CASE	UDP-S24073
PROJECT NAME	315 NE 3rd Street
APPLICATION TYPE	Site Plan Level II
APPROVAL LEVEL	City Commission Approval
REQUEST	Design Deviation Request to Increase Podium Height and Reduce Tower Separation for 607 Multifamily Units and 3,727 Square Feet of Commercial Use and Affordable Housing Density Incentive Requests in the Downtown Regional Activity Center
APPLICANT	Arosa Developers, LLC.
AGENT	Stephanie Toothaker, Esq.
PROPERTY ADDRESS	401 NE 2nd Street
ABBREVIATED LEGAL DESCRIPTION	Geo M Phippens Subdivision B-146 D A Por Of Lots 13 Thru 16 Blk B
ZONING DISTRICT	Regional Activity Center – City Center (RAC-CC)
LAND USE	Downtown Regional Activity Center
COMMISSION DISTRICT	2 - Steven Glassman
NEIGHBORHOOD ASSOCIATION	Flagler Village Civic Association
SUBMITTAL	December 13, 2024
COMPLETENESS ISSUED	December 18, 2024
EXPIRATION	June 16, 2025 (180 Days)
WAIVER	Not Requested
CASE PLANNER	Yvonne Redding, Urban Planner III

Applicant REV 1 responses are bolded and dated April 4, 2025

Applicant REV 2 responses are bolded and dated September 11, 2025

Case Number: UDP-S24073

NORTHEAST CORNER SIDEWALK ALONG NE 3RD ST

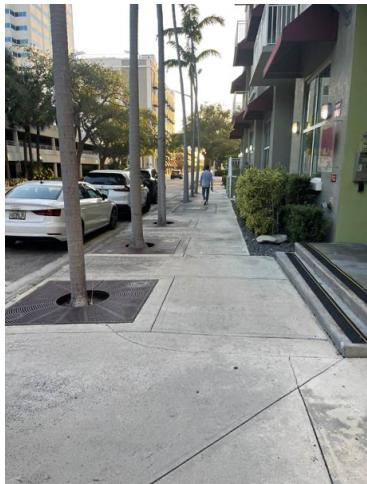
DSD-ENG Response 05/16/2025: Comment not fully addressed. Thanks for providing the photos shown below, but please also depict on Sheet AR-001 the location/configuration of existing public access sidewalks (perhaps superimposed from the 'ALTA/NSPS Land Title Survey') for the areas just beyond where the proposed sidewalks will harmonize with existing sidewalks.

REV 2 Response: The NE 3rd Street sidewalk has been updated for a better transition with the existing sidewalks. See added Sheet AR-007

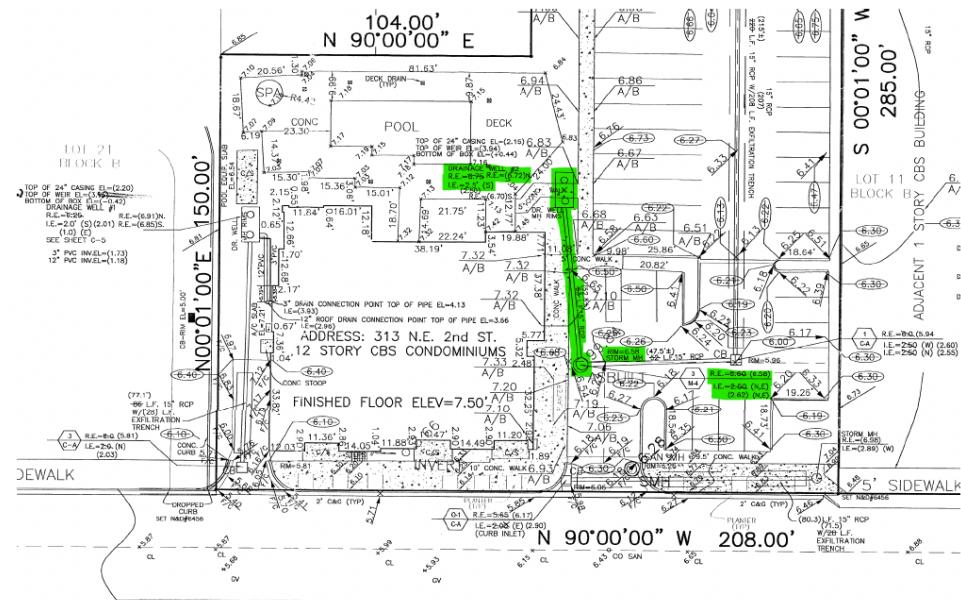
e. **DSD-ENG New Comment 05/16/2025:** Per DSD-Traffic staff request to complete half of 60' Right-of-Way section for a minor collector, please show/label delineation in the plans for proposed 10' ROW Easement (i.e. instead of proposed 5' ROW Easement) that abuts the adjacent NE 2nd St R/W.

REV 2 Response: The requested 10' ROW easement line has been added to Sheet AR-001/003 and the civil sheets.

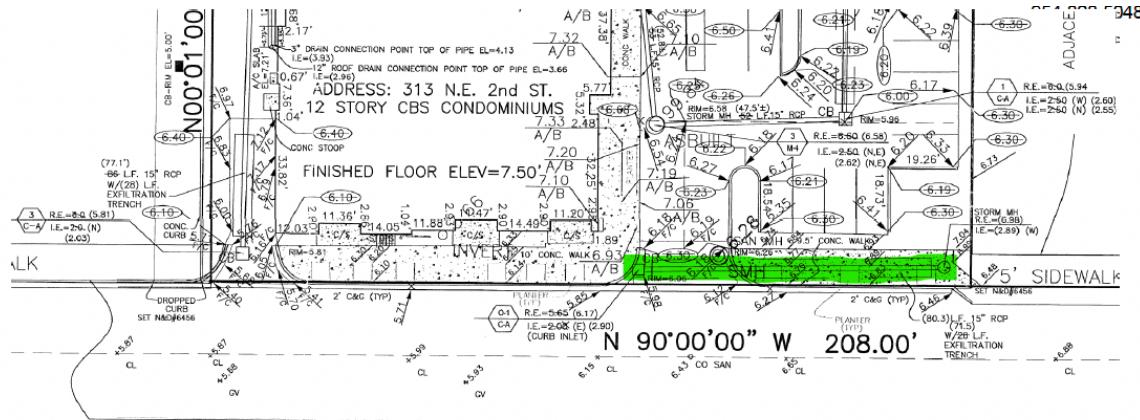
- c. Elevations of building access to/from NE 2nd Street public access sidewalk (i.e. 5.50 NAVD) are not consistent with Architectural Sheets AR-001 and AR-111 (i.e. 3'-10" NAVD); please reconcile and update plans as appropriate.

REV 1 Response: The architectural drawings have been updated. See Sheets AR-001 and AR-111.

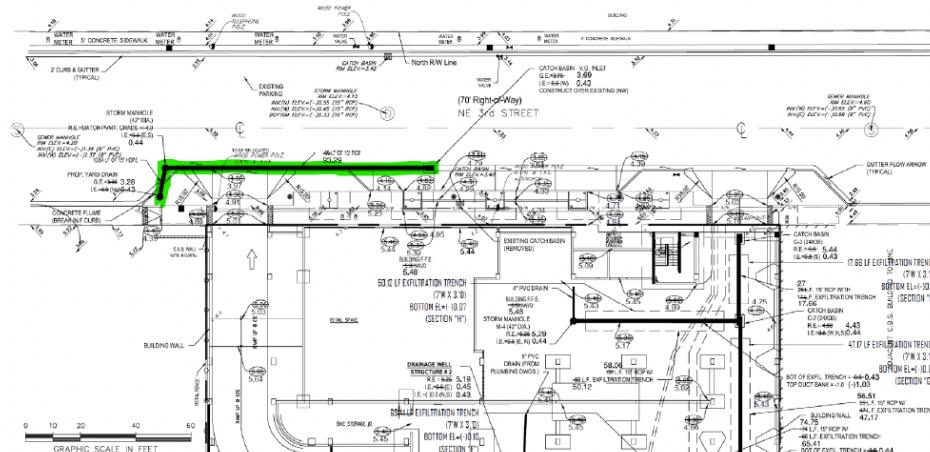
e. Label disposition of existing stormwater inlet (i.e. within curb & gutter), concrete power pole, concrete light pole, and pedestrian sidewalk access handrails located within adjacent NE 3rd Street R/W.

DSD-ENG Response 05/16/2025: Comment not fully addressed, please clarify that 'Existing Power Pole to be Removed, Light Pole to be Relocated' (i.e. for consistency with callouts on Sheet AR-001/Site Plan), and show/label both existing pedestrian access handrails to be removed.

REV 2 Response: See updated sheet AR-001

12. Sheet C3 (Conceptual Water & Sewer Plan):

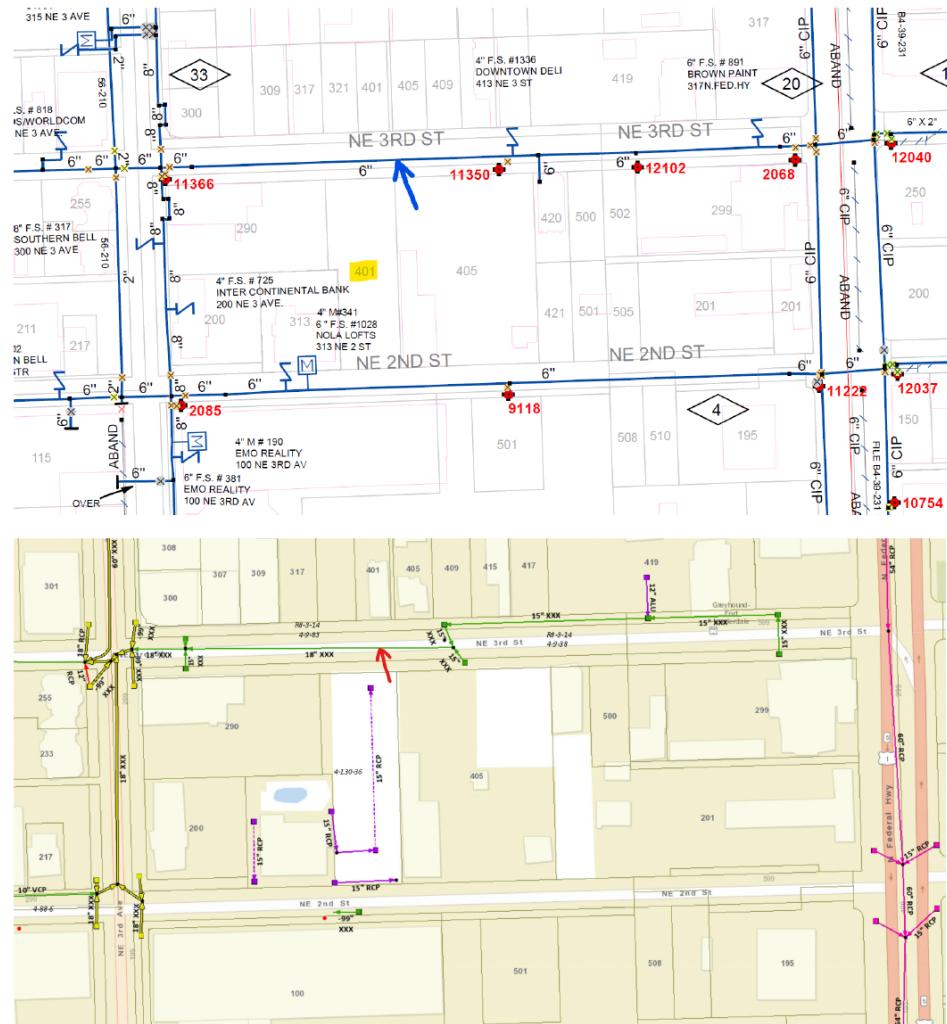
a. Label size/material of existing City water mains and sewer mains located within the adjacent NE 2nd Street R/W and NE 3rd Street R/W.

i. In order to properly design the proposed connections to the City's water and sewer infrastructure, please email PLAN@FORTLAUDERDALE.GOV to obtain copies of the City utility atlas maps and as-built plans adjacent to the proposed development.

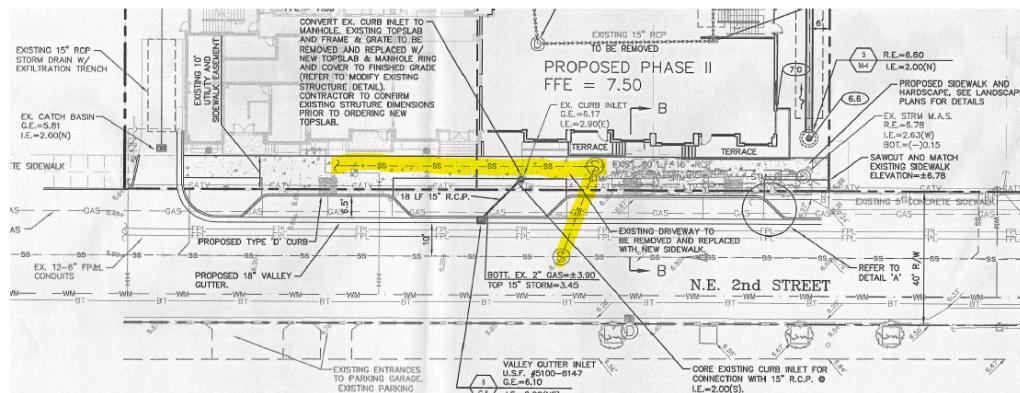
DSD-ENG Response 05/16/2025: Please shift location of proposed 10' x 15' Water Easement (and 6" Water Meter if needed, keeping it centered within the easement) such that it does not overlap the proposed 10' R/W Easement to be recorded along north side of adjacent NE 2nd St.

REV 2 Response: Please refer to revised sheet C3.

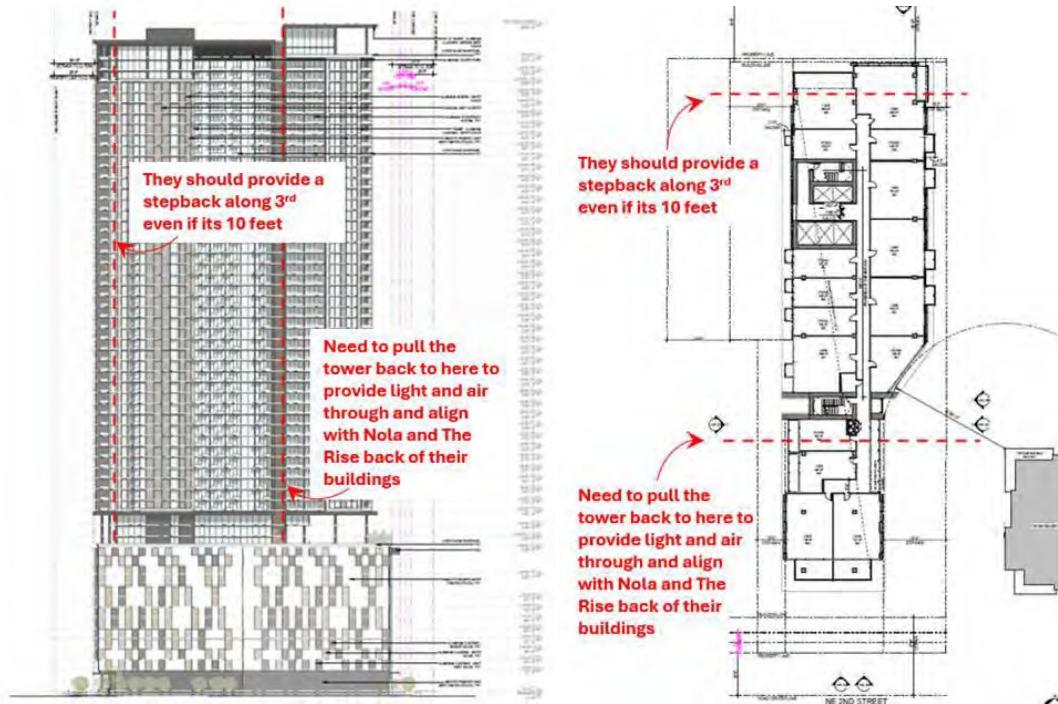
1) *Ground level design.* It is the intent of the DMP to provide higher floor to ceiling heights, especially on the ground floor, to enhance the overall public realm experience. The portions of the building facing primary and secondary streets should have taller ceiling heights to create dramatic and elegant building forms with a compelling street presence and sense of arrival. In addition, the DMP encourages richer material palettes, more intensive details and lighting for the street level, and high-quality durable exterior materials. A rich layering of architectural elements throughout the building, with special attention to the ground floor and podium façade need to be provided. See images.

REV 1 Response: A higher floor-to-ceiling height has been provided at the 3rd Street main entrance, creating a more impactful access. Additionally, high-quality materials have been considered for the podium façade (see sheets AR-203/AR-204). A new 3D aluminum cladding design has been incorporated for the podium façade, adding texture that changes the perception of the façade depending on shadows and sunlight conditions. See updated renderings AR-801 to AR-806

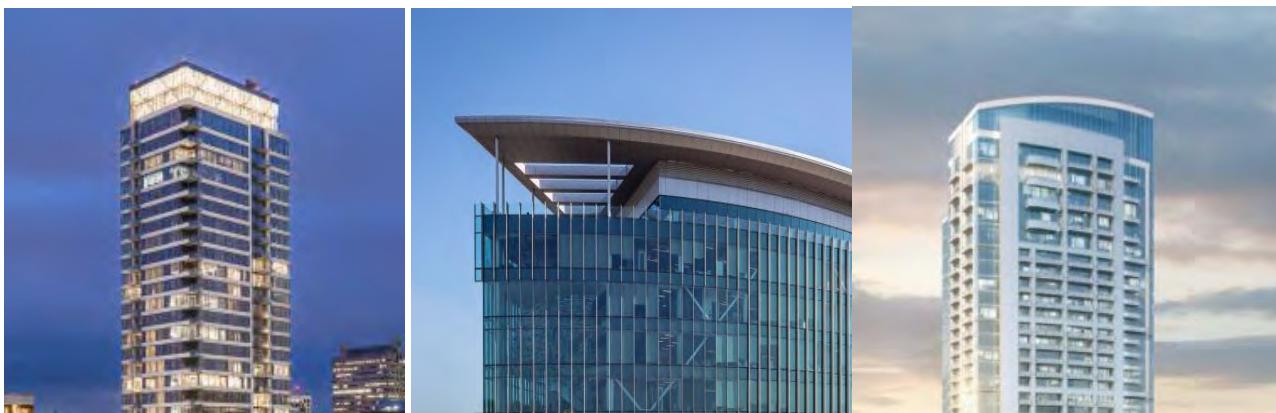
e. B-22, Increase ground floor ceiling height in relation to overall building height. A minimum of 28 feet along NE 3rd Street should be provided.

REV 1 Response: See updated sheet AR-203. A 30 feet ceiling height is provided.
